LiDAR Quality Assessment Report

OR_OLCRogue_2012

WSI has collected Light Detection and Ranging (LiDAR) data of the Rogue River Study Area for the Oregon Department of Geology and Mineral Industries (DOGAMI). The Oregon LiDAR Consortium's Rogue River project area encompasses approximately 1.4 million acres in the southwestern region of the state. The area includes portions of the Siskiyou National Forest, the City of Grants Pass and the Rogue River.

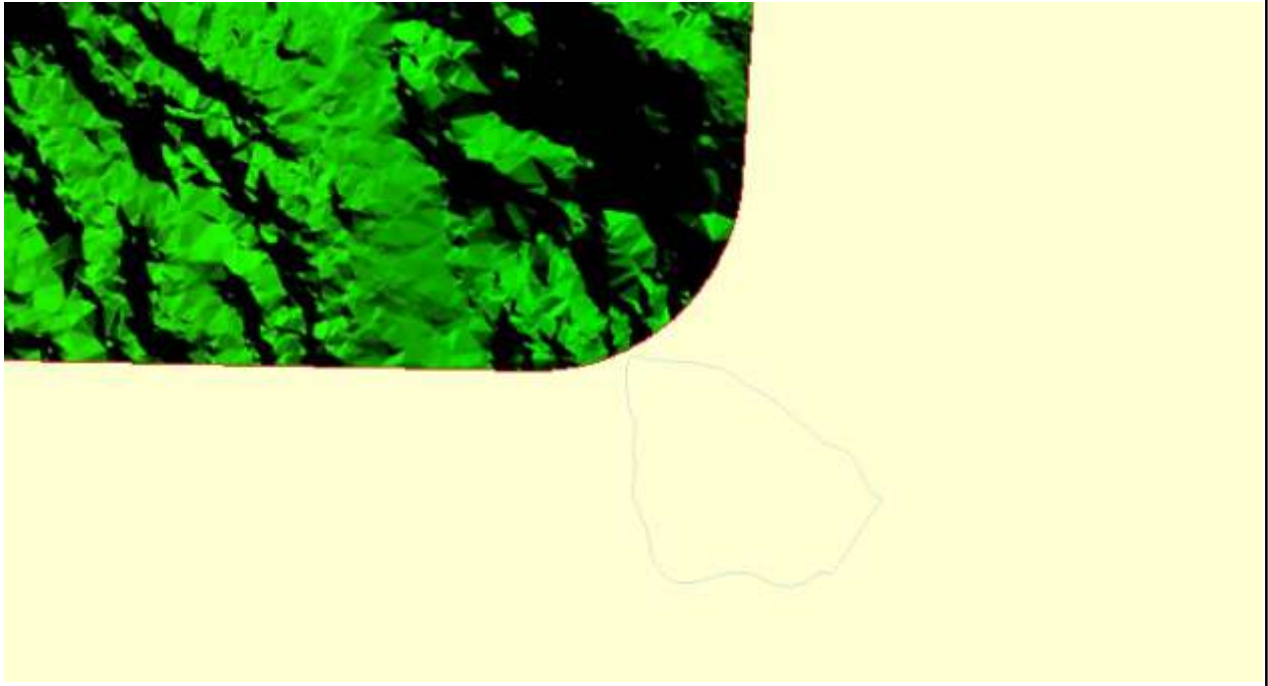
Hard to see in the image above, there are a few areas where bare earth terrain has a heavily "tinny" character than surrounding terrain. This is characteristic of many areas throughout the dataset. This is largely due to the heavy forest canopy interrupting many pulses in their way to the ground. Subsequent examination of the point cloud was used to see if the ground filters used in these areas were aggressive enough in classifying points to bare earth. It was found that the filtering done was adequate and that the surface models are the best representation of the bare earth from the LAS data.

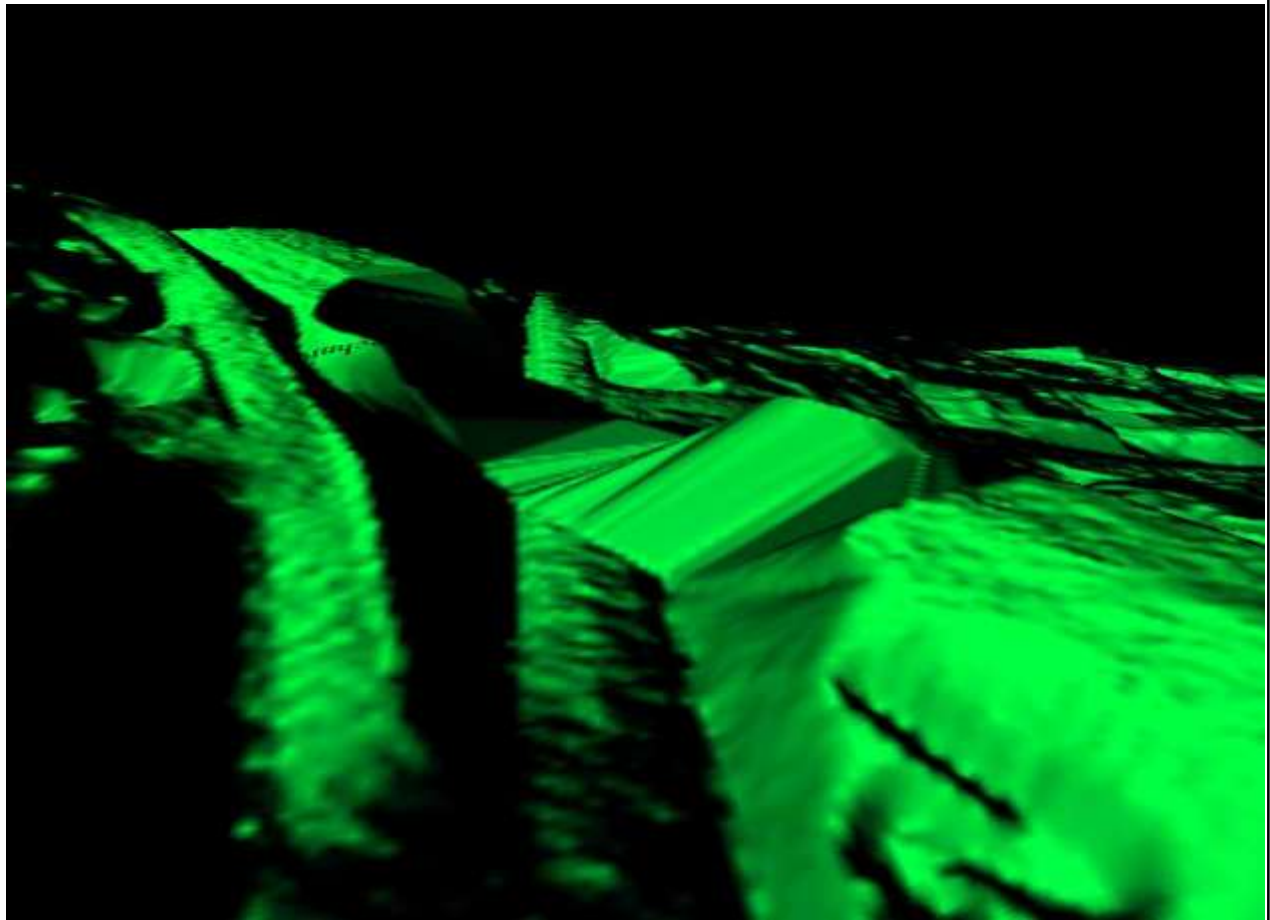
There was an instance of a Breakline falling outside the delivered DEM data, issue is of little consequence to DEMs.

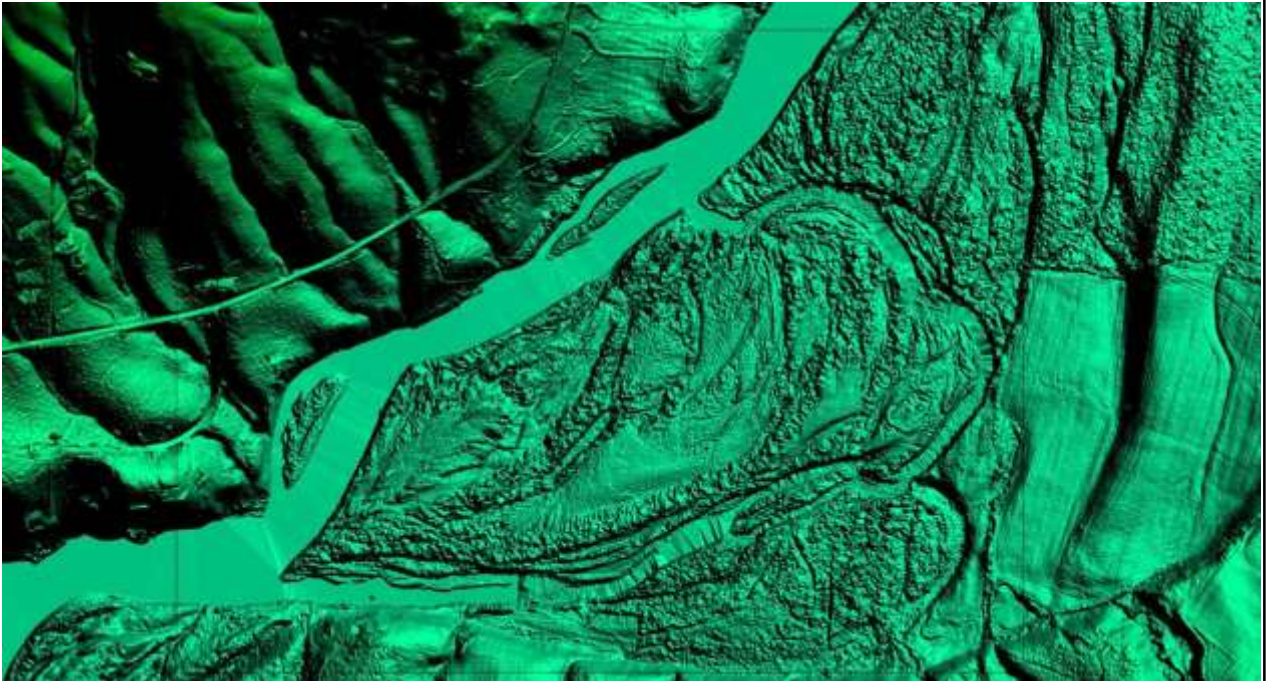
There were several instances of Bridges that could have been removed more cleanly (via Breaklines, etc...); however the bridges have been adequately removed for the project.

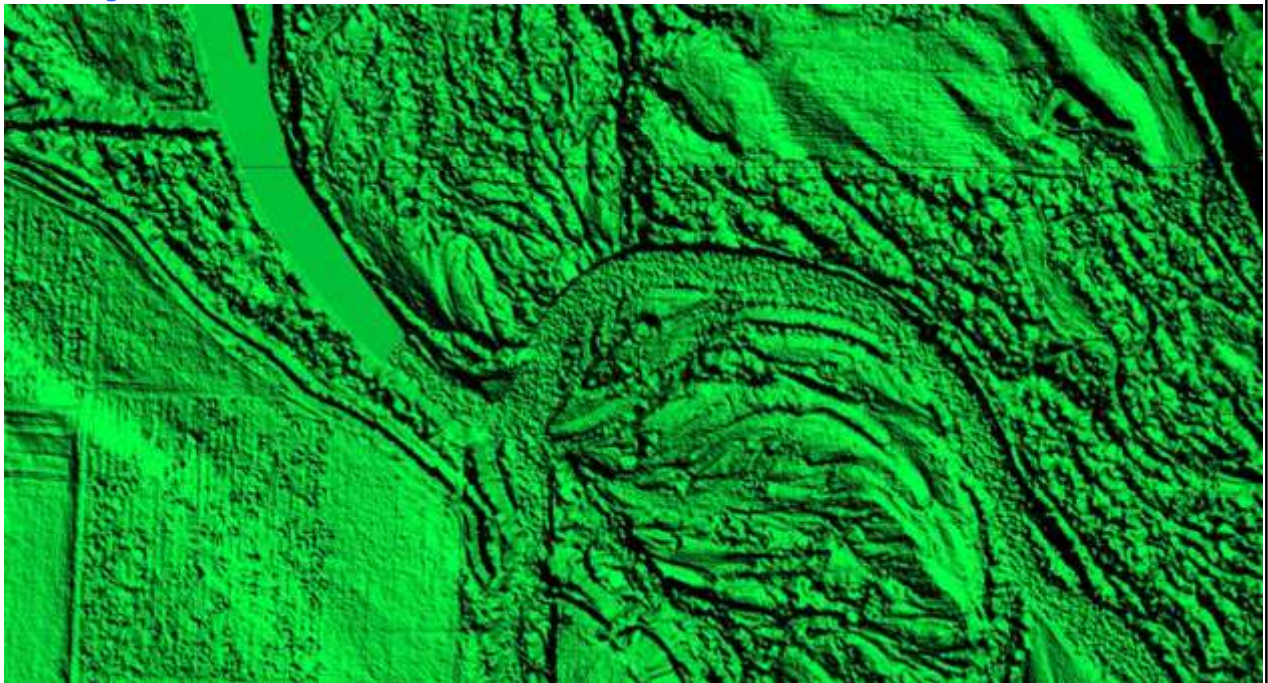
All Water bodies greater than 2 Acres were hydroflattened. Likewise, the vast majority of sloping streams greater than 100ft width were flattened in a downstream monotonic manner as well; however, there were several instances where the water could have been flattened or flattening is called into question, see the image above and those below. Pictured above is a channel breaking off from the main hydro flattened stream that was not flattened. The most recent NAIP Imagery shows this area as being connected. These instances are few in number throughout the project.

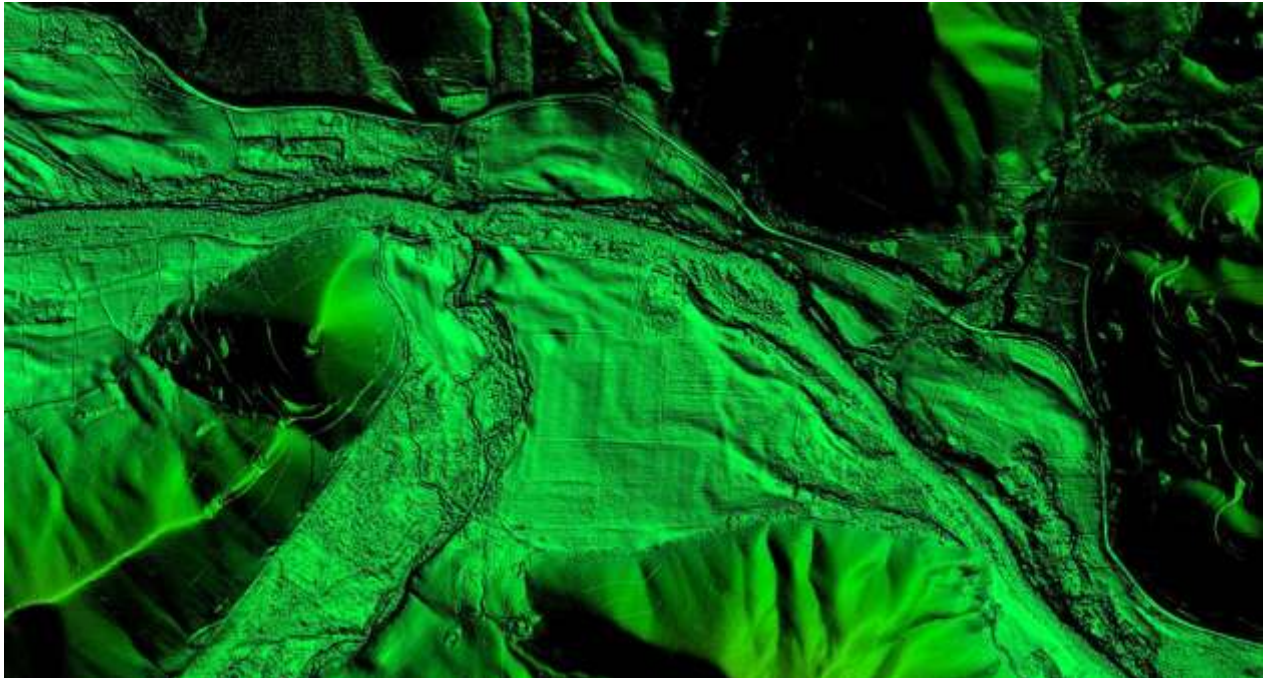
This is the location where hydroflattening stops for the "Applegate River" and everything south of this river is not flattened. The density of the stream bed suggests that the water level may have been very shallow or dry at the time of capture and would not require flattening if that were the case. NAIP Imagery shows both dry conditions and wet conditions for this river south of this location, images below will show the character of river in the DEMs.
